MEMORANDUM

Case # 15-05

SUBJECT: Proposed Revisions to Section 616 Reclaimed Water Line Construction and NEW Reclaimed Valve Box detail

| DETAIL NO. TBD- 2 |  MARICOPA ASSOCIATION of GOVERNMENTS STANDARD DETAIL ENGLISH | RECLAIMED WATER VALVE BOX INSTALLATION | REVISED 3/4/15 Draft | DETAIL NO. TBD- 2 |

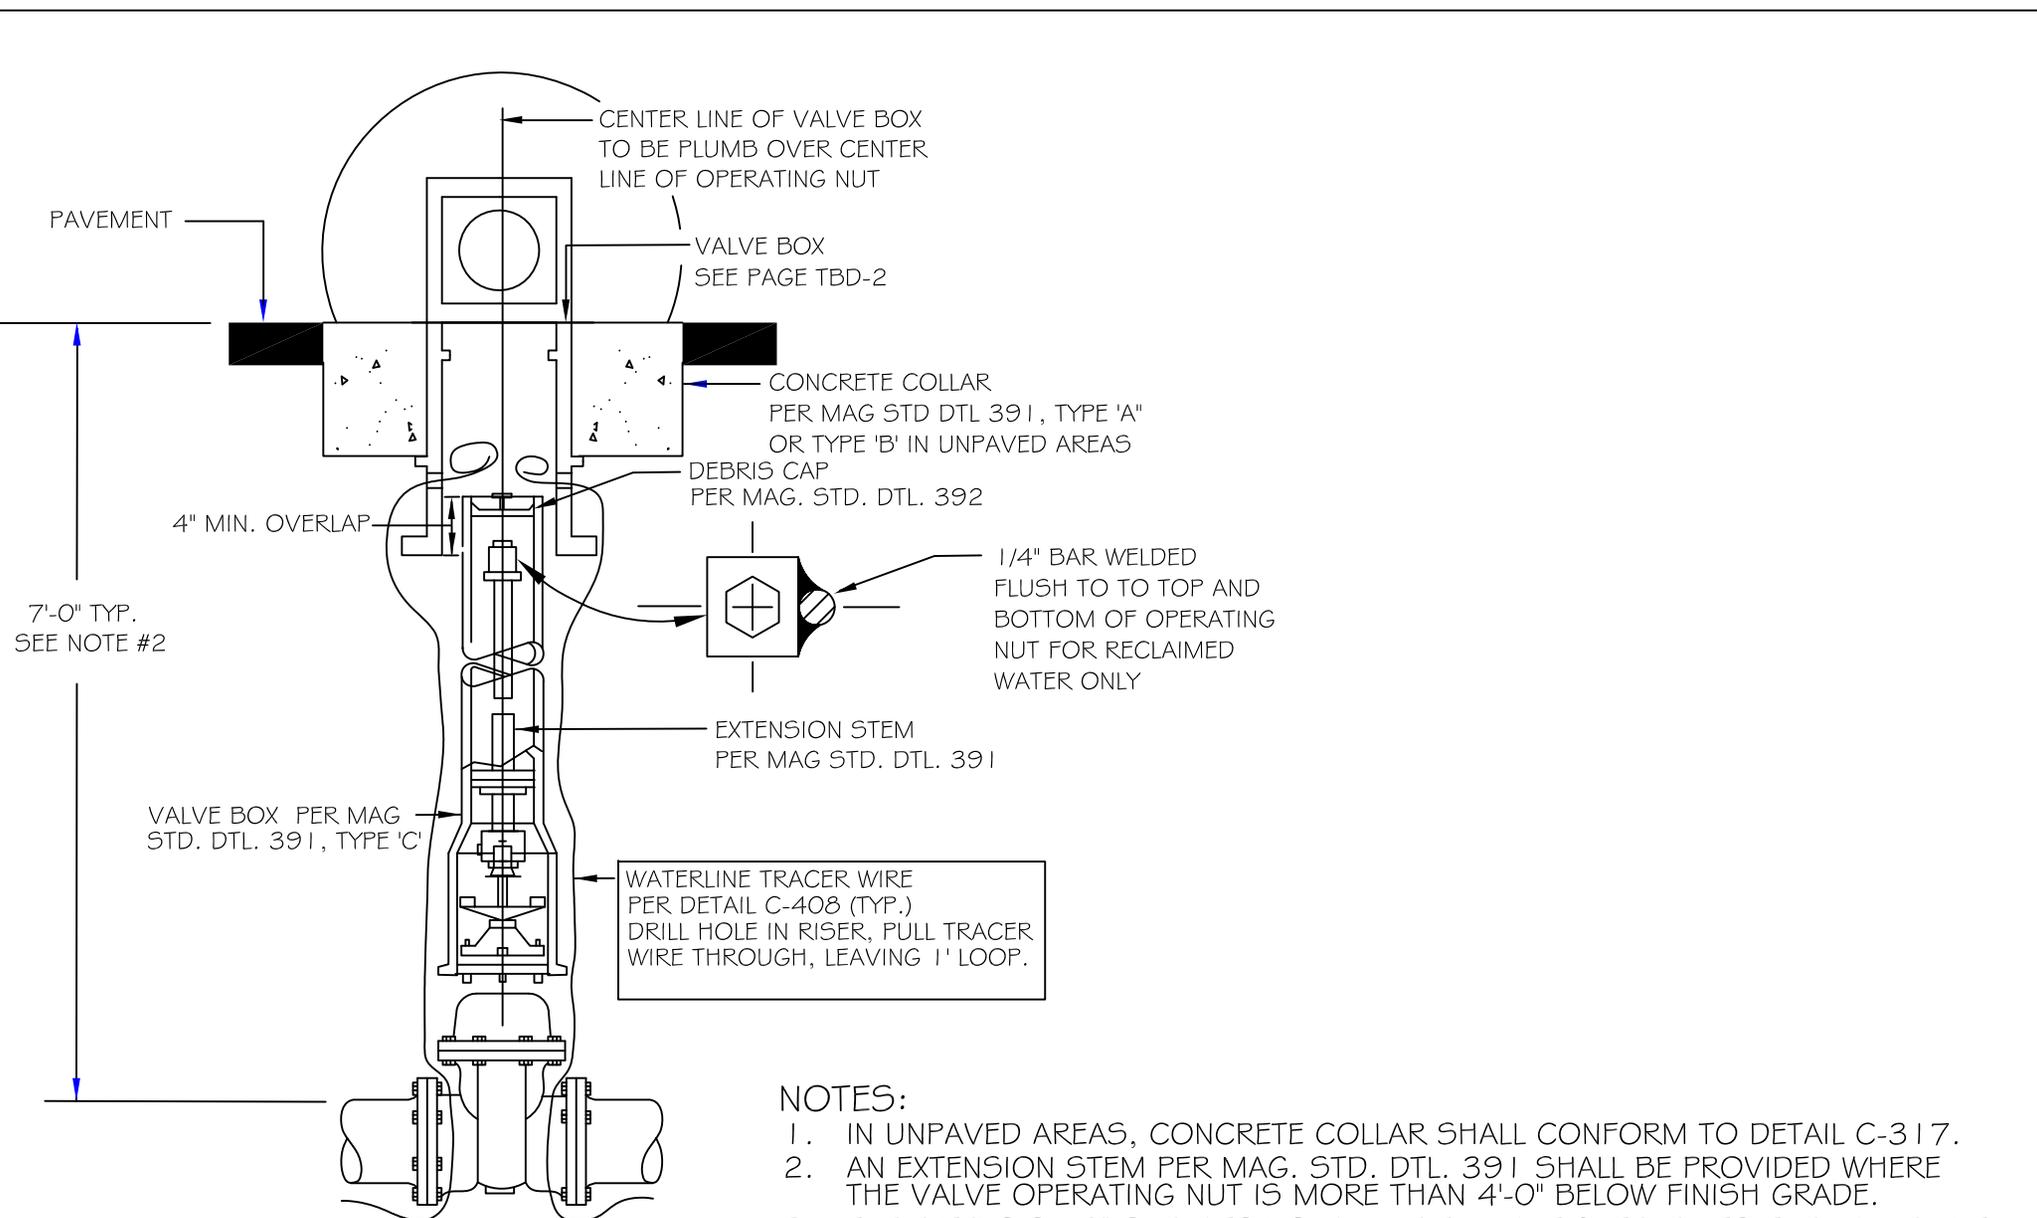
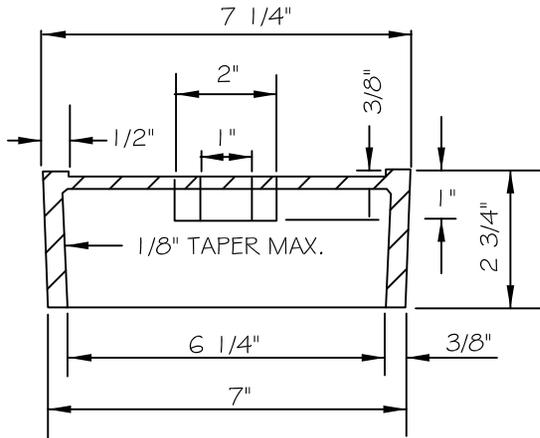
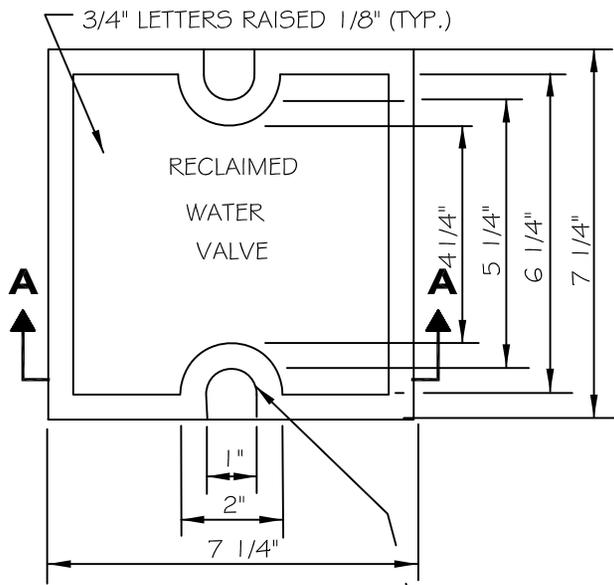
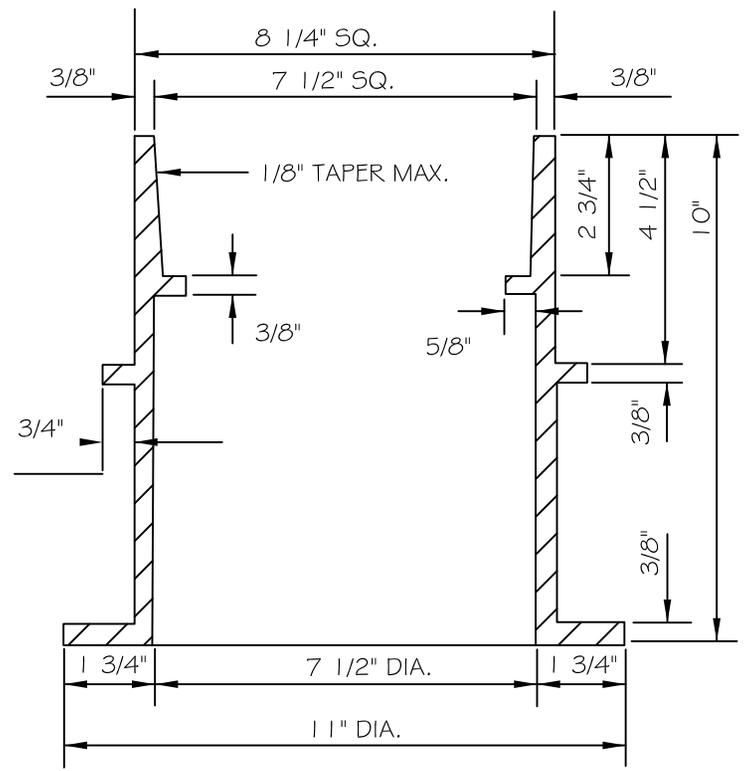
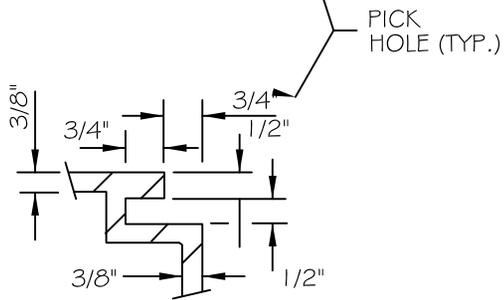
2. New Reclaimed Valve Box Detail No. TBD

See attached initial DRAFT for further development.
